GOLD PARK HOMES

MCLAUGHLIN AND MAYFIELD  
BRAMPTON, ON

SITE PLAN

LOT NUMBER  
108

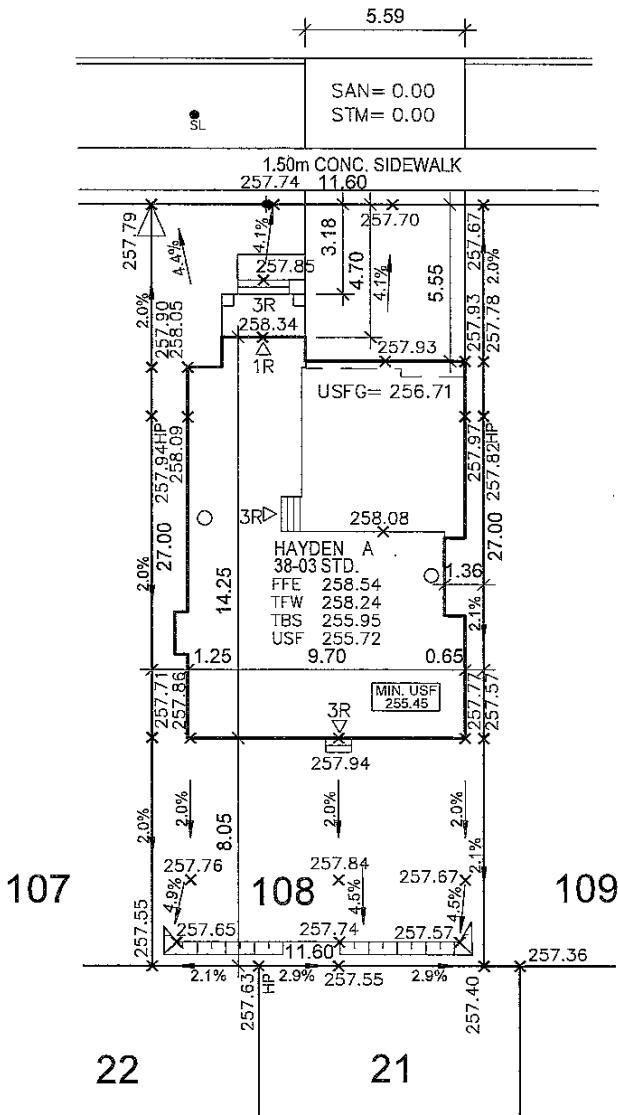
- 1) No final utility location information at this time. Urbantech will not be responsible for future changes to design. Builder should notify purchaser's that street hardware and above ground utility furniture may be added or removed from their frontages.

- 2) Builder to lower underside of footings where adjacent to RLCB leads. Exact depth to be determined on site during footing excavation.
- 3) Builder to stake out driveway curb depressions at time of curb installation.

- 4) Builder to verify location of all hydrants, street lights, transformers and all other services. If min. dimensions are not maintained as per City standards, builder is to relocate at his own expense.

- 5) Builder to confirm service connection elevations and review for absence of conflict prior to footing excavation.
- 6) Final fence design have not been provided at this time. Purchaser to be advised that actual fencing details may not be as shown on this plan.
